Report on the discussion of vibration in CN-JP-OICA web-meeting

2019.12.

Date: October 18, 2019

OICA

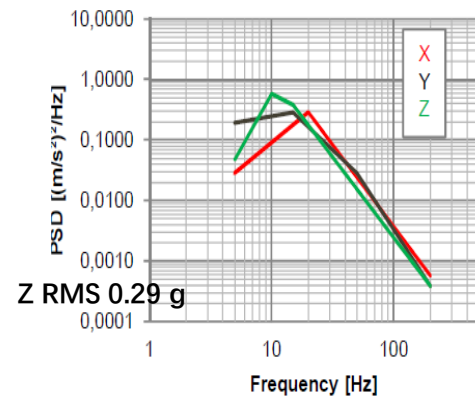
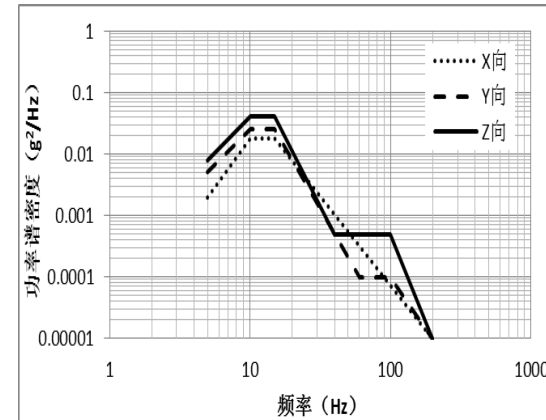
- It was mentioned that the upper vibration frequency of 200Hz is too high for heavy duty vehicles and a modified profile is under investigation. When will it be proposed and discussed?
- Regarding LIV, please show us the specific calculation formula and input numerical data. LIV of China profile should also be calculated, and then compared.

China

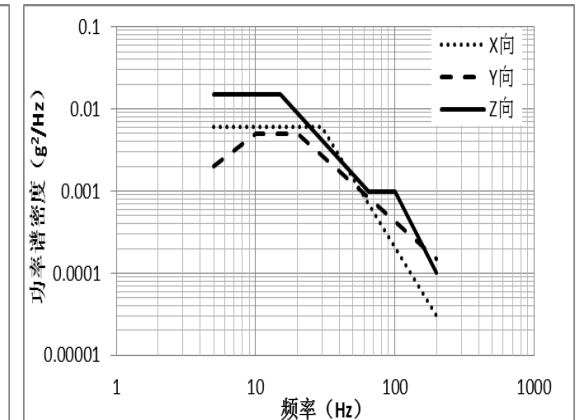
- Is the rough road structure for passenger vehicles different from that for commercial vehicles? If so, what are the grounds?
- There are two different conditions for commercial vehicle tests, one for Cargo-van and the other for Bus. Which one is used for the derivation of the vibration profile?
- Are the commercial vehicle tests conducted with loads, or without loads?
- What are the grounds of the life time mileage of 300,000 miles? How many years are expected as the vehicle life time?

- What is China's feedback regarding the removal of sinusoidal vibration tests (24Hz, 1hr, three directions) ?
- What is China's feedback regarding the elimination of time acceleration?
